20 June 2013

Exhibition Wallarah 2 Coal Project EIS - Application No. SSD-4974

A complete copy of PSM's report is attached with the findings summarised below. Wyong Shire Council objects to the current proposal based on the findings and recommendations contained in PSM's report.

Figure 14: Statistics of flows in Jilliby Jilliby Creek, 1972 – 2013

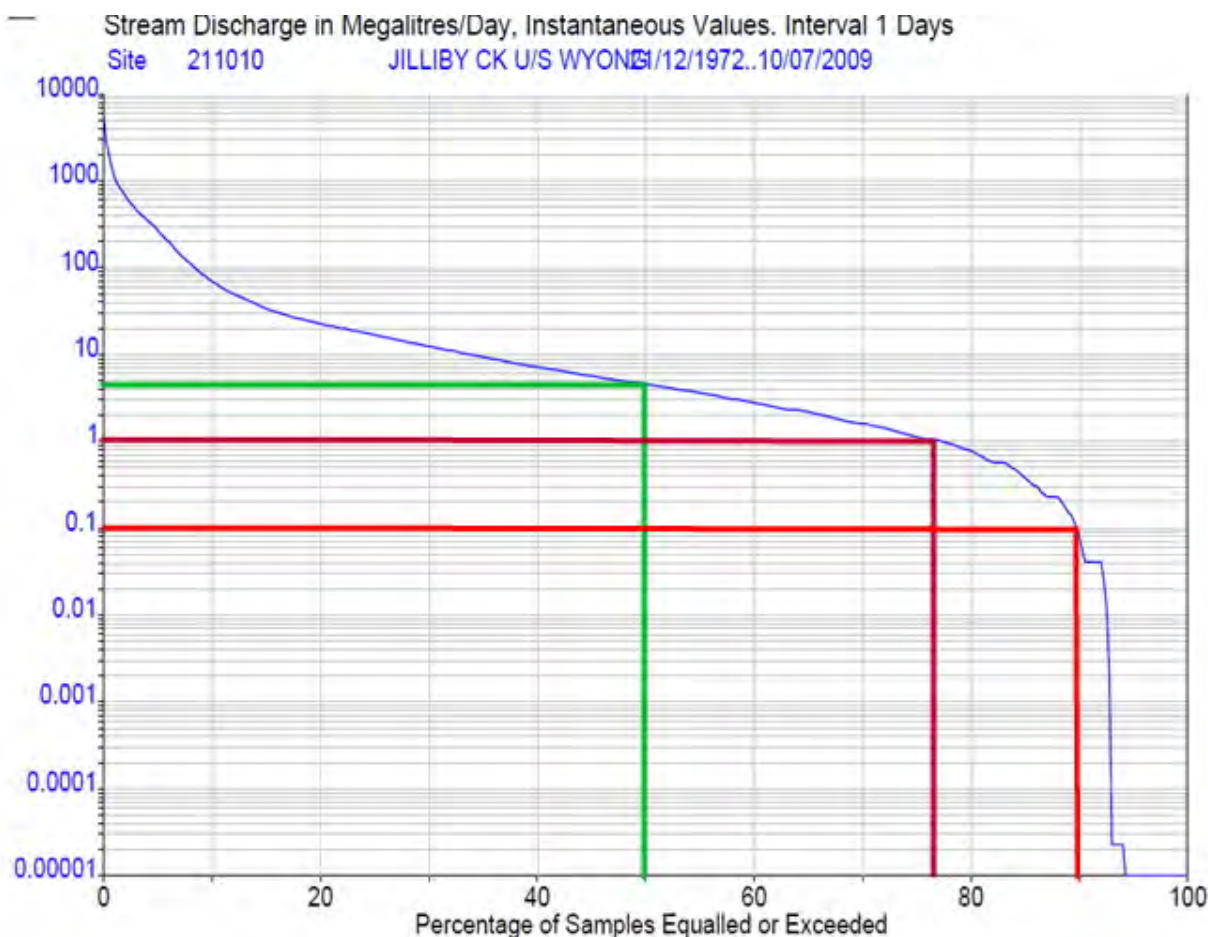
From the plot above it can be seen that the median flow rate is about 4.5 Megalitres per day (ML/day). However, the flow is less than 1ML/day for 24% of the time of record, and less than 0.1 ML/day for 10% of time.

Figure 16: Droughts in Wyong are shown by 113 years of rainfall records at Wyee. Downward slopes are periods of below average rain; the steeper the slope the more intense the drought; the longer the downward sloping period the longer the drought.

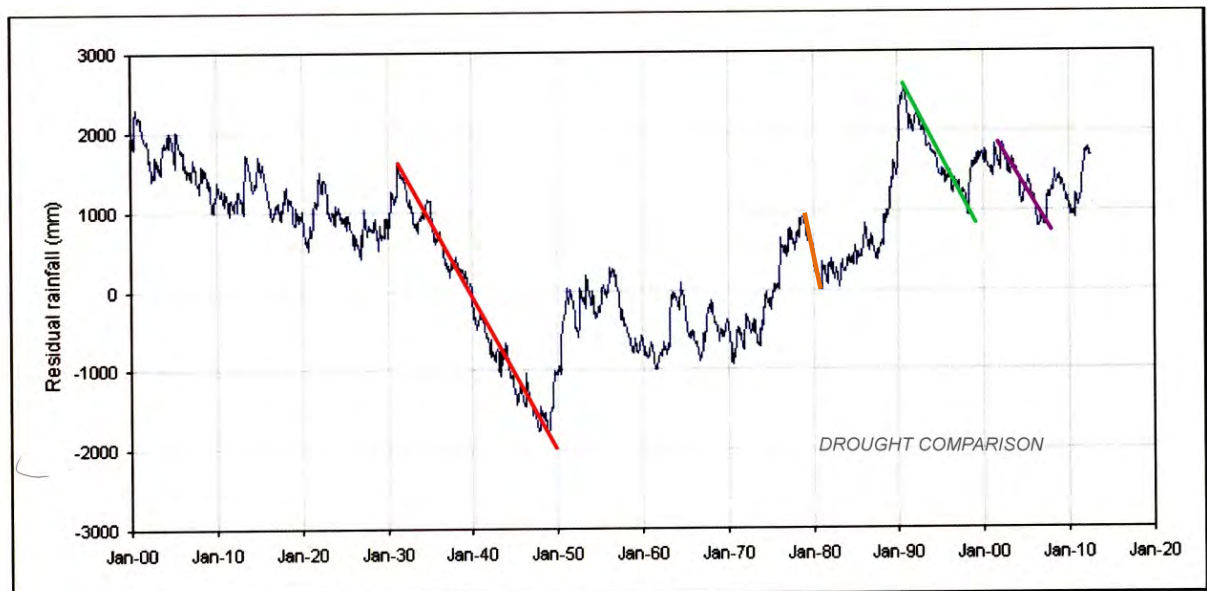
It is valid to compare the data in Figure 16 with the flow records of Jilliby Jilliby Creek.

It is readily seen that 2.5ML/day of mine inflow is more than half the average flow of Jilliby Jilliby Creek and is greater than the flows recorded for 40% of the time since 1972. It is reasonable to assume that the periods of low flow in the creek (see Figure 14) may be longer in future under climatic conditions similar to those experienced since 1972.

Figure 17: Computed mine inflows as given in the EIS

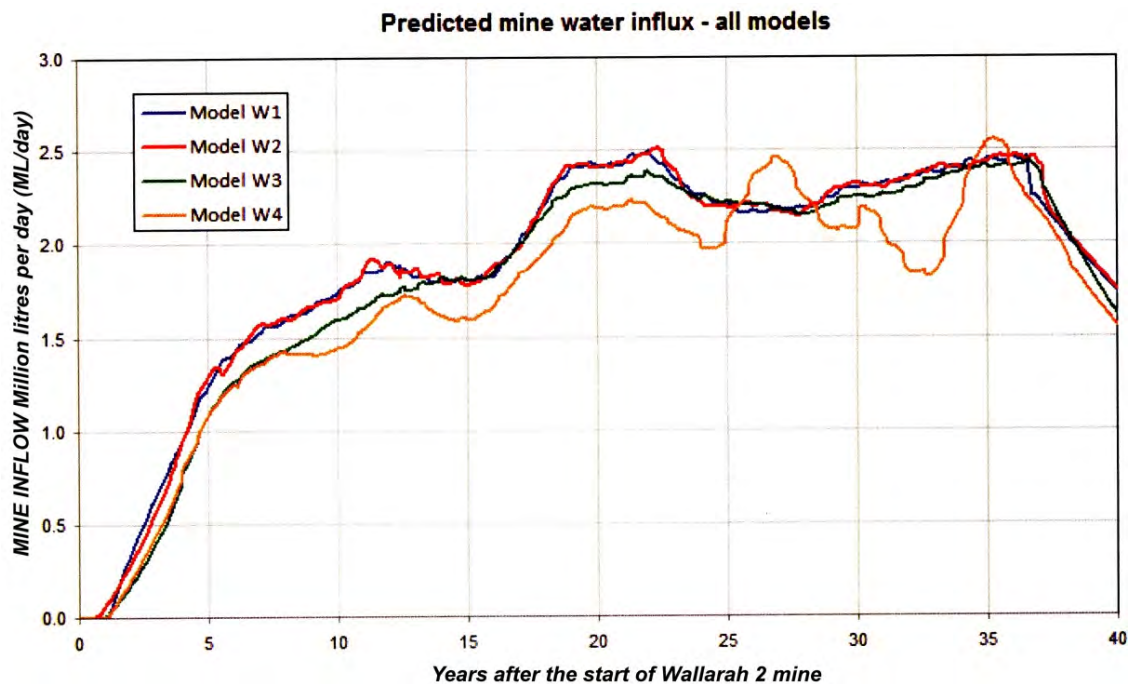
It can be seen that computed inflows reach about 1.5ML/day in Year 6 and are up to 2.5ML/day for 15 to 20 years after about Year 18. The EIS also notes that these calculations do not include flows from fracture zones which are estimated to potentially increase inflows by about 0.5ML/day.

The EIS does not provide any attempt to reconcile where this water comes from. It implies that it would largely come from water stored in the ground, but this avoids the fact that water stored in the ground comes from somewhere, and is in equilibrium with natural recharge. A valid way to consider this matter is encapsulated in the following quotation from Dr Rick Evans, principal hydrogeologist of Sinclair Knight Merz, viz:

Figure 18: Pre-mining groundwater regime from Figure E17 of Appendix H of the EIS

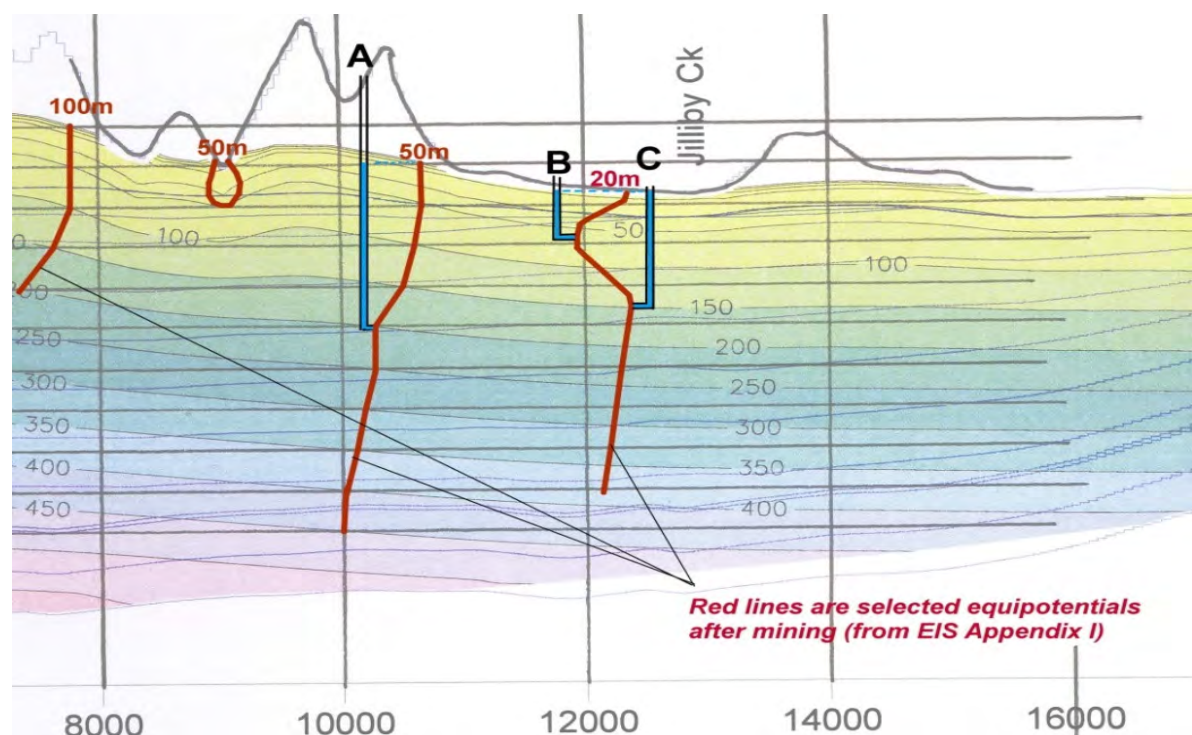
Figure E17 of Appendix H of the EIS gives calculations of the groundwater pressure regime around the mine under natural conditions, at the end of mining (Year 38). In this form the plots do not provide guidance on near surface flow lines that illustrate the flow path. The discussion and figures below set out to present the data from the EIS in a practical form to illustrate the impact of creating a groundwater sink in the form of the underground mine.

Figure 18 is an annotated version of part of the EIS plot of natural groundwater conditions above the mining area. To interpret the plot 'equipotential lines' have been annotated onto the EIS data. Equipotential lines indicate the level the water in a well will rise to which on the Figures below is benchmarked against the height above sea level (AHD). So in the case below the equipotential lines show the level water would rise to in a well open only at the bottom, whose bottom is placed on that equipotential line.

The water level in the well is shown by the blue column for each well. It can be seen that the two wells (B and C) on the 20m equipotential line rise to the same level, namely RL20 m.

Figure 19: Prediction in the EIS of the groundwater regime at completion of mining

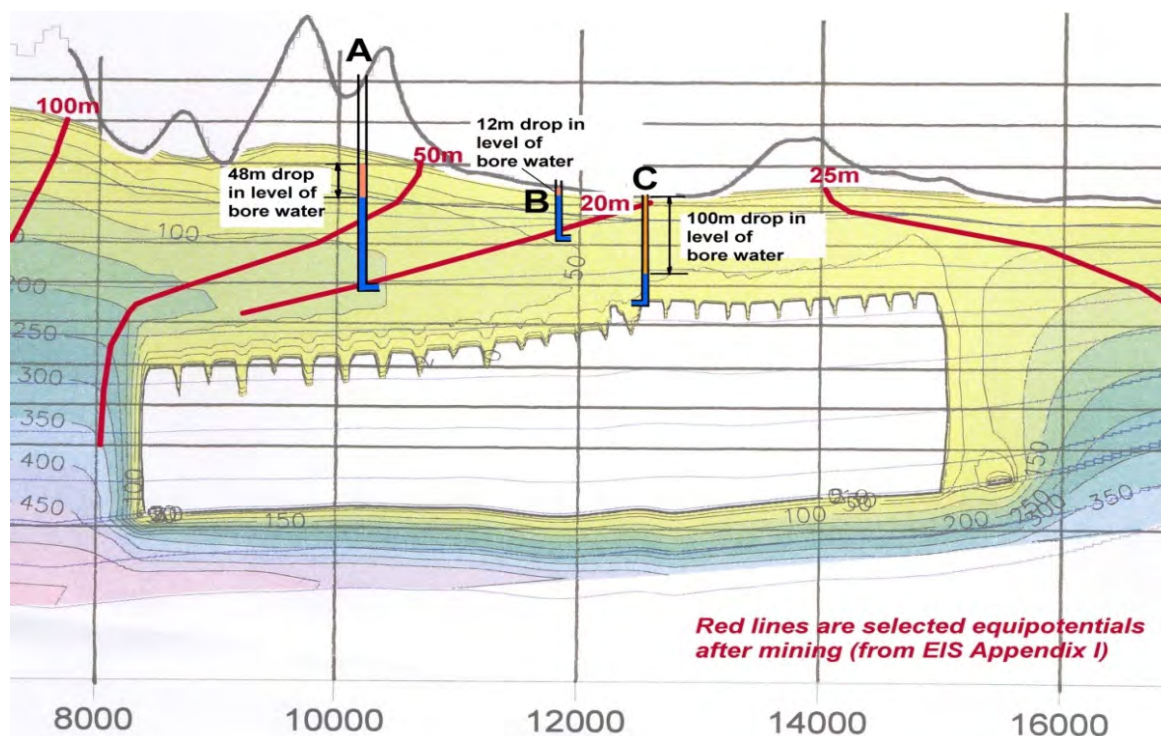
Figure 19 is the prediction in the EIS of the groundwater regime at completion of mining. Again, selected equipotential lines and the three imaginary wells are annotated onto the figure. The water levels in these wells predicted at the end of mining are again shown by the blue columns. The drop in level for each well is shown by the orange column and as written on the figure. It can be seen that:

- the water level in Well A drops 48m;
- the water level in Well C drops 100m; and
- the water level in the mid-range, 70m deep, Well B drops 12m.

Water level drops in the wells annotated above are substantial and indicate significant changes to the groundwater regime. These pressure drops within the rock must reflect in pressure decreases within the shallow alluvium within the Dooralong Valley, and these decreases, in turn, cause the decrease in base flows to Jilliby Jilliby Creek that are discussed earlier.

Figure 20 Vertical Permeability values from Appendix F of the EIS versus values used in groundwater impact assessment in Appendix G (After Figure 2.35 Valley Case)

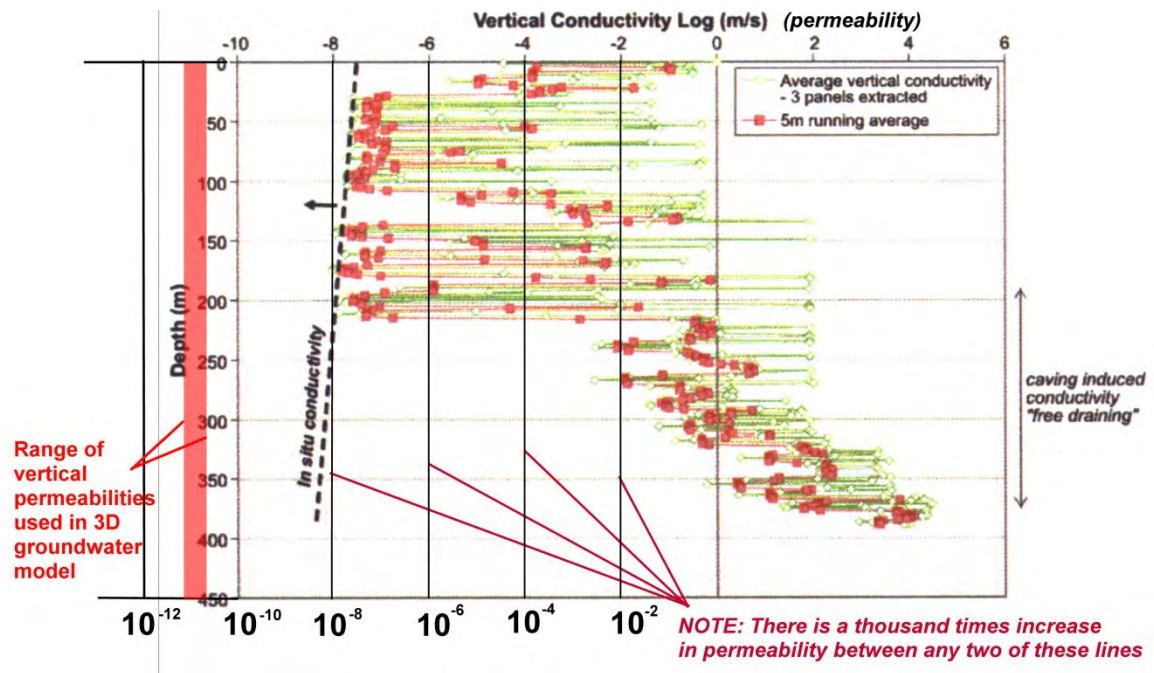
These permeability profiles are very different from those adopted in the MER model, upon which groundwater impacts are assessed.

To demonstrate the large differences between what the EIS states as being appropriate permeability ranges, and what has actually been used in the EIS to assess impacts on the groundwater regime, we have plotted, in Figure 20, the parameters used by MER (3D model) against the 'valley' case permeability ranges given in Appendix F.

Figure 20 indicates that the hydraulic conductivity values adopted in the MER W2CP model are substantially on the low side of any realistic range of possibilities which have been identified within the EIS itself. If the values provided in Figure 20 were adopted the computed mine inflows, and the rate at which depressurisation progresses through the strata would be substantially higher.

Figure 21 Distribution of synthetically generated permeability values in the constrained zone by MER – Figure 27a in Appendix H of the EIS

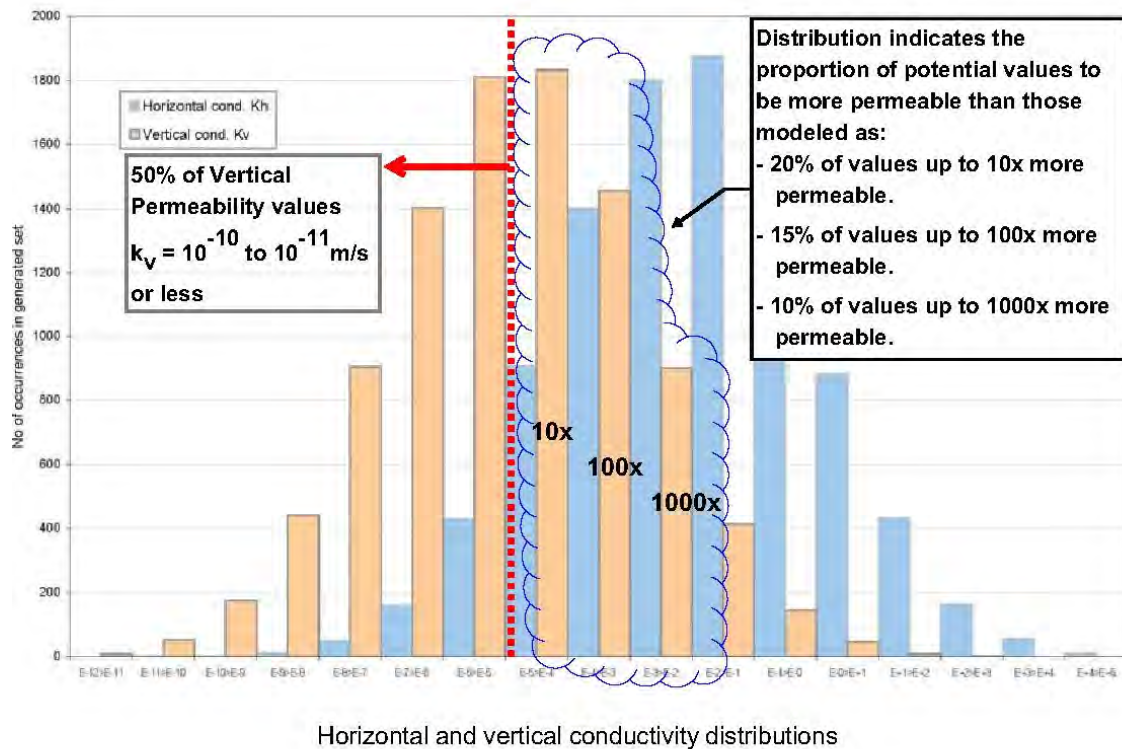
Indirectly MER appear to agree with this assessment. Figure E27a from Appendix I repeated below as Figure 21, shows a distribution plot of vertical (k_v) and horizontal (k_h) conductivity for the Constrained Zone from a synthetically generated randomised distribution.

Interpretation of the data presented in Figure 21 shows that at about 50% of the realisations of vertical permeability have a value equal to, or less permeable than those modelled by MER (about 10^{-11} m/sec or 10^{-6} m/day). However, this indicates that 50% of the potential realisations of permeability are more permeable than those modelled. While it must be acknowledged that the plot below is a probabilistic one, it does show another view that permeability could be higher. The order of increased permeability values shown are:

- 20% of values have a value of k_v up to 10 times greater than those modelled
- 15% of values have a value of k_v up to 100 times greater than those modelled
- 10% of values have a value of k_v up to 1000 times greater than those modelled

Figure 22 Depressurisation curves extracted from the plots of the MER W2CP model given in Appendix G of the EIS

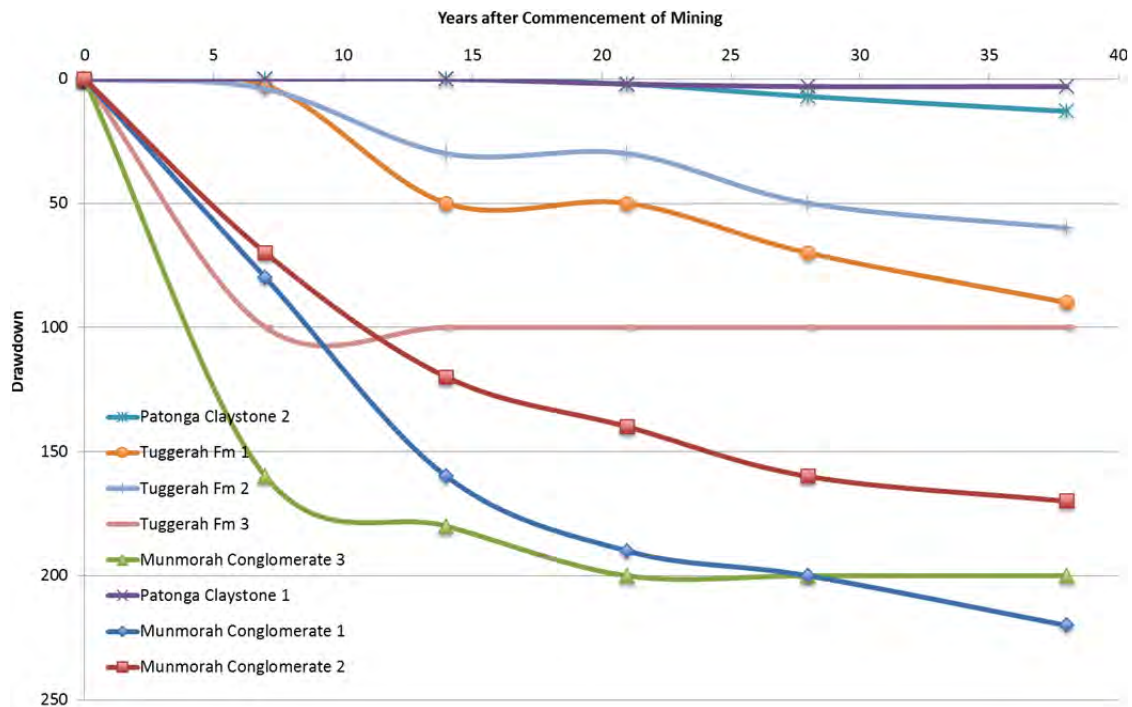
Figure 22 summarises the progression of depressurisation through the strata from the MER model, a process still continuing after 38 years. If MER had adopted the parameters recommended in the previous chapter in same EIS then depressurisation would have been calculated as occurring much faster and to a much greater extent.

Therefore, the flow quantities and extents of depressurisation discussed in Section 8.2, above, must be viewed in the context that they are non-conservative in respect to impacts on groundwater and surface waters. Therefore, the significant impacts actually shown by the MER model, as outlined in Section 8.2, could readily be more adverse, and at the very least warrant assessment with regard to sensitivity and risk.

Figure 25: Main Areas of Increased 1% AEP Flooding – Dooralong Valley

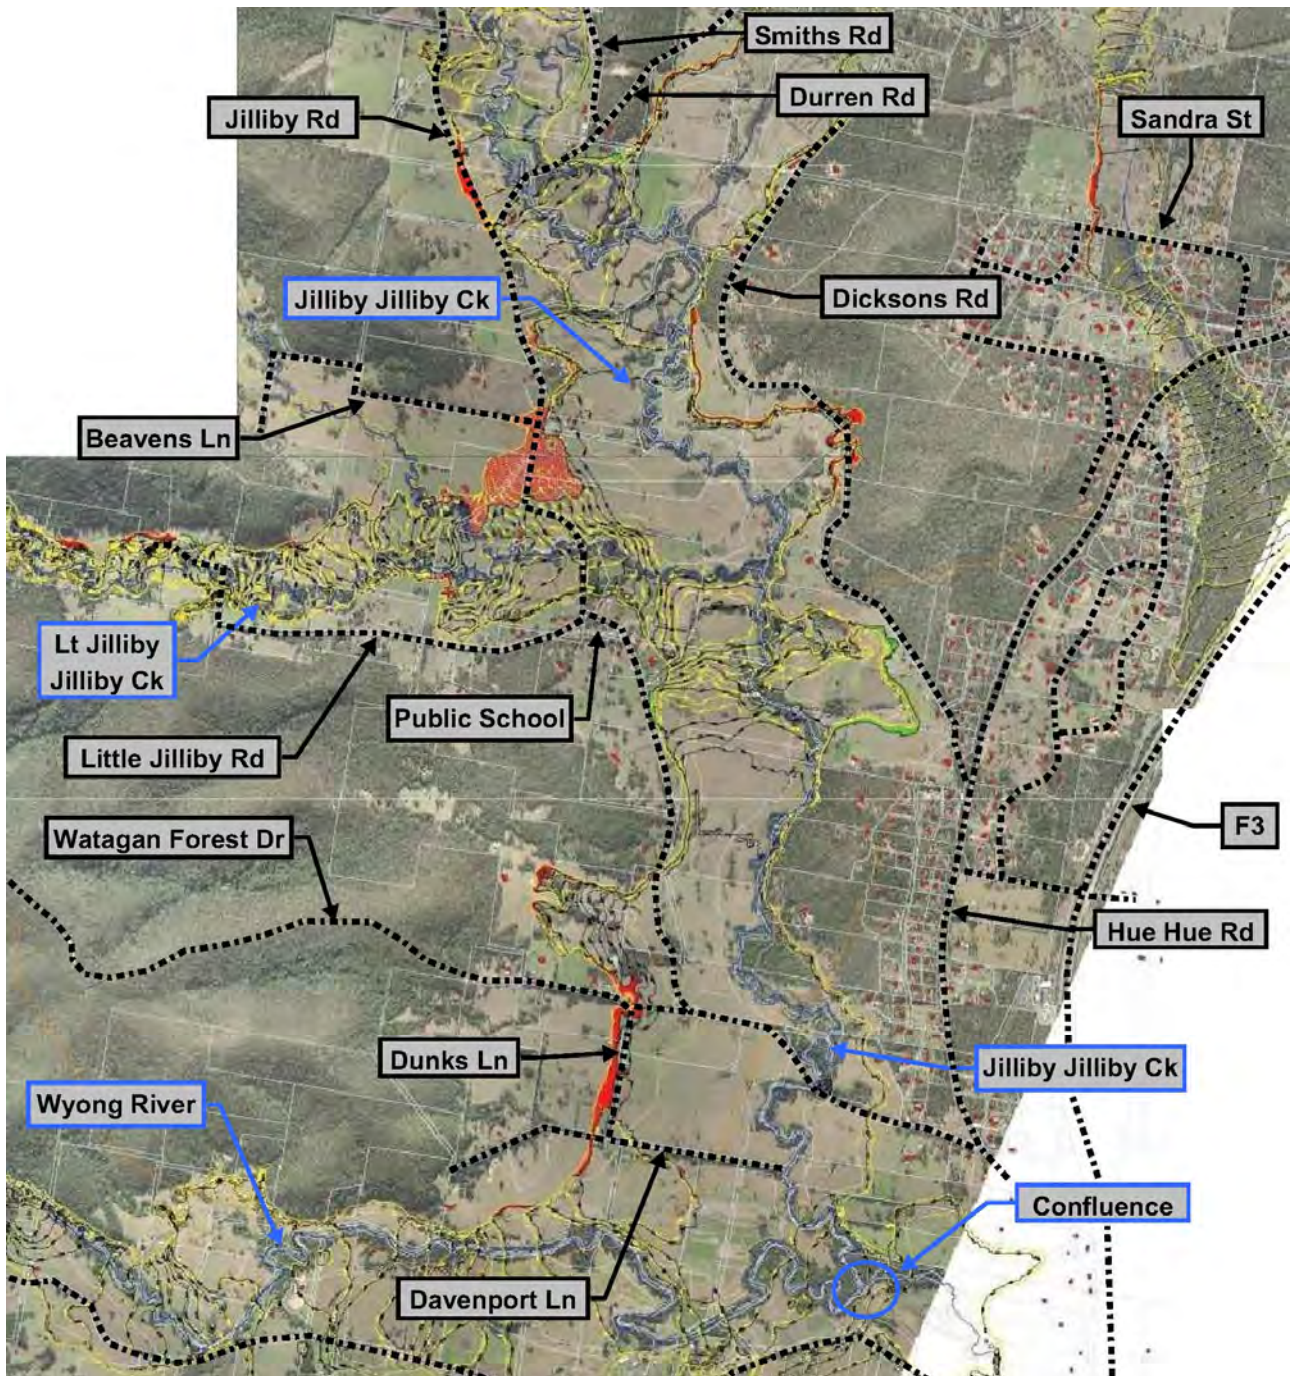
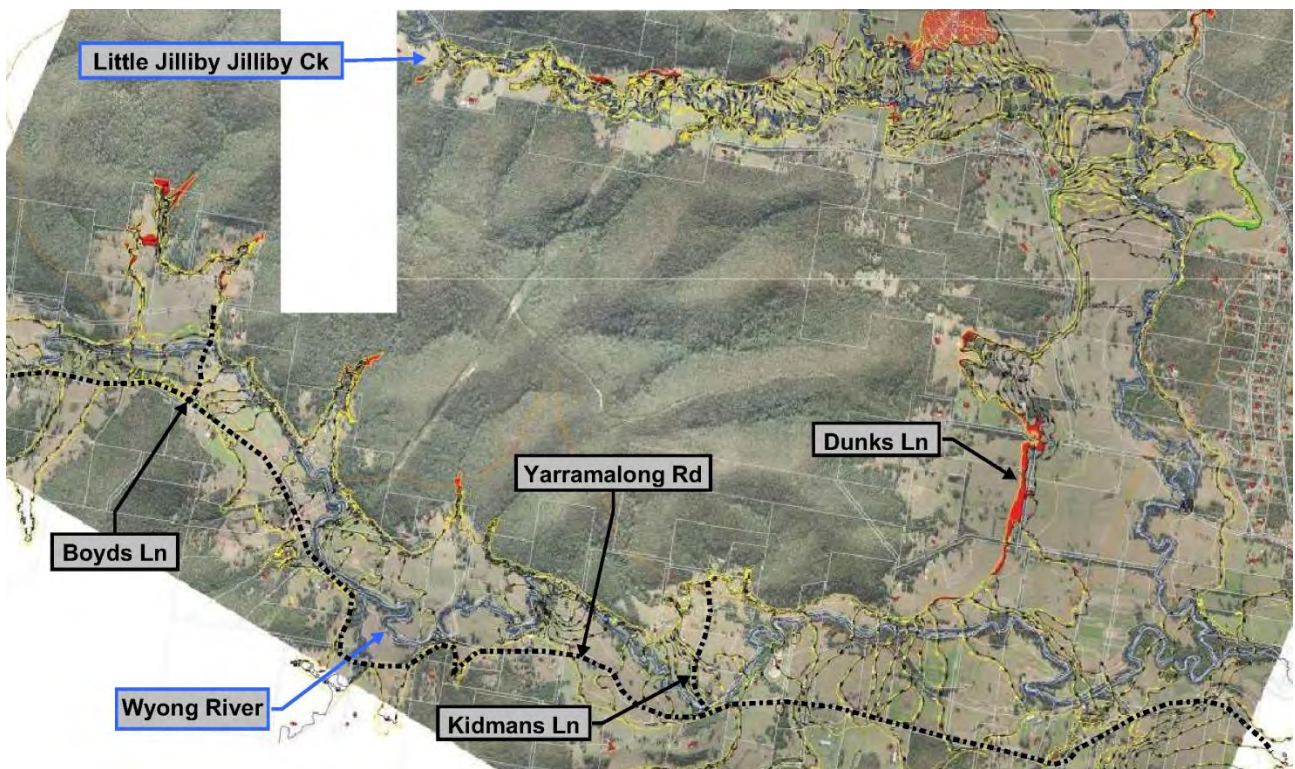
A minor, but significant point from the aspect of EIS review is that of presentation. It is difficult to interpret with any confidence what the flood levels are on the 1%AEP flood maps included in Annex I to Appendix K nor from the various Figures throughout the text of the EIS. Indeed, the only clearly defined data is that presented in Tables 6.1 to 6.5 of Appendix K with the limitation as to no actual identification of dwelling.
